Project: I-405, Brickyard to SR 527 Improvement Project
Contract No: 009727

Subject: **Design Related Delays & Impacts for SR-522 Transit Hub Power Source Location**

I-405, Brickyard to SR 527 Improvement Project: Contract Change Scope of Work

I-405, Brickyard to SR 527 Improvement Project: Contract Change Scope of Work
 Change Title: Revised PSE Power Routing to Transit HUB Date: **10/27/25**
 Change No.: **PCN-00093**

Figure 1 - RFP Preliminary Electrical and Communication Plan

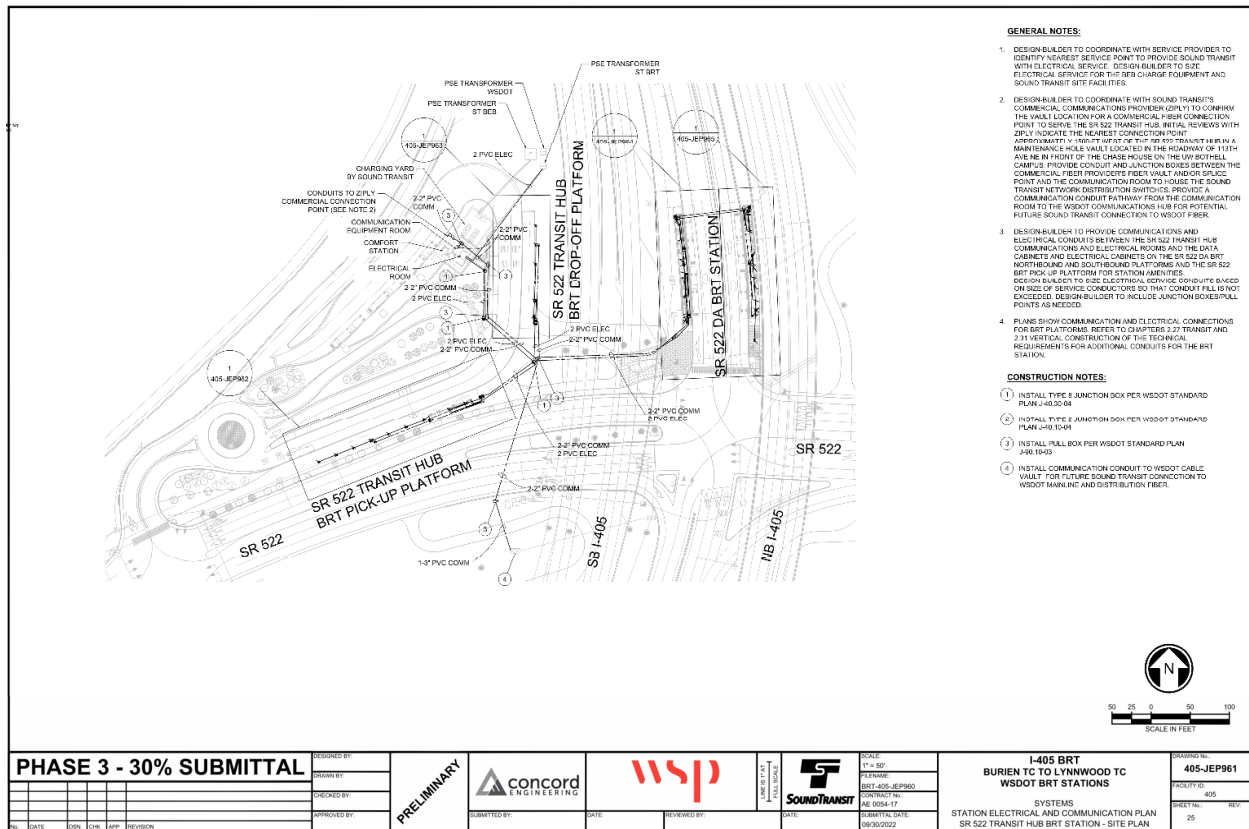
Figure 1 is the preliminary electrical and communication plan provided in the RFP documents for the SR522 Transit Hub. This was included in the document "S04_Sound_Transit_BRT_Station_Design_Plans_and_Detail.pdf" as part of Appendix S. It did not identify a power source location – but during the RFP stage the discussions with WSDOT led the team to getting power near UW Bothell.

Figure 2 - RFC package drawing

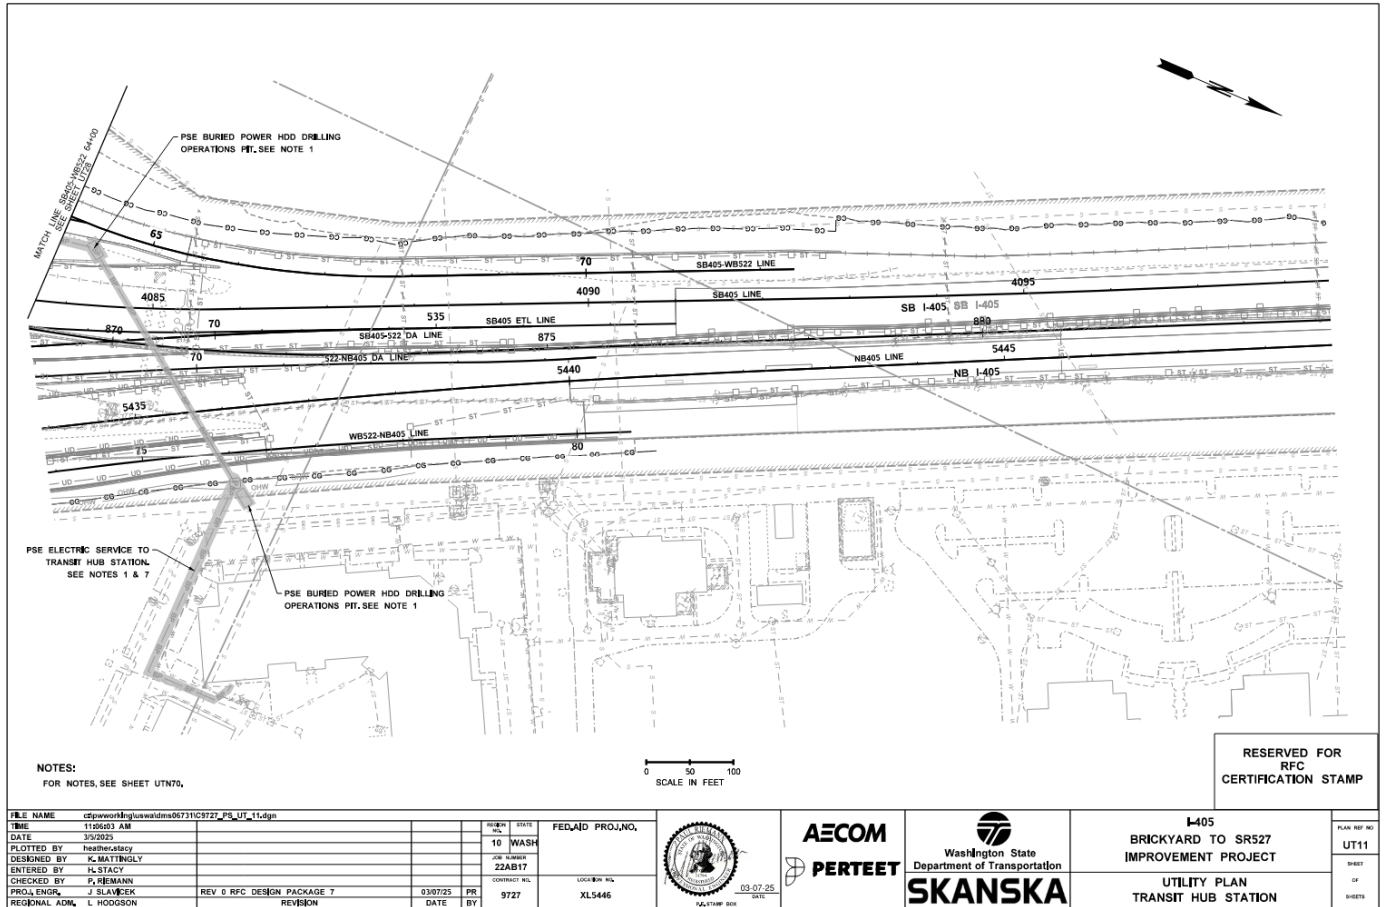
After NTP, subsequent meetings with PSE continued to focus on getting power for the SR 522 Transit Hub Station and the SR 522 DA BRT Station. Preliminary designs focused on a mostly overhead system that would be designed and built by PSE (consistent with the RFP language). As PSE continued to evaluate the routing, they determined that they would not be able to route power from the UW Bothell location. This was because PSE and WSDOT could not agree on a route for maintenance/access and WSDOT permitting. Subsequent meetings settled on the nearest available point from which PSE could provide a route for power would be from the NE quadrant of the I405/SR522 interchange (Bothell 405 Business Park).

PSE has now stated that they expect the design-builder to design and construct the power connection between the site at Bothell 405 Business Park and the SR 522 Transit Hub Station transformer. This change to the SOW of work for the utilities design will include the following:

Coordinate with PSE and WSDOT to evaluate and confirm alternative routing to provide electrical power to the SR 522 Transit Hub Station transformer that is different than the alignment from the UW Bothell location discussed during the RFP stage. The design team (Pereteet) will prepare a horizontal plan and vertical alignment for the conduit and casing for the electrical conductors to provide electrical power to the SR 522 Transit Hub transformers based on Figure 2 above. PSE will size and design the electrical cables and the transformers for the SR 522 Transit Hub. The following are additional scope of work elements triggered by these changes:

- Coordinate and confirm with PSE location of alternative source of power from the original location near UW Bothell.
- Develop horizontal alignment and plan for conduit system for electrical power from Bothell 405 Business Park to the SR 522 Transit Hub transformers.
- Develop vertical alignment and profile for conduit system for electrical power from Bothell 405 Business Park to the SR 522 Transit Hub transformers. Include profile of casing for a single 4 in. conduit under I405 using a horizontal direct drill (HDD).
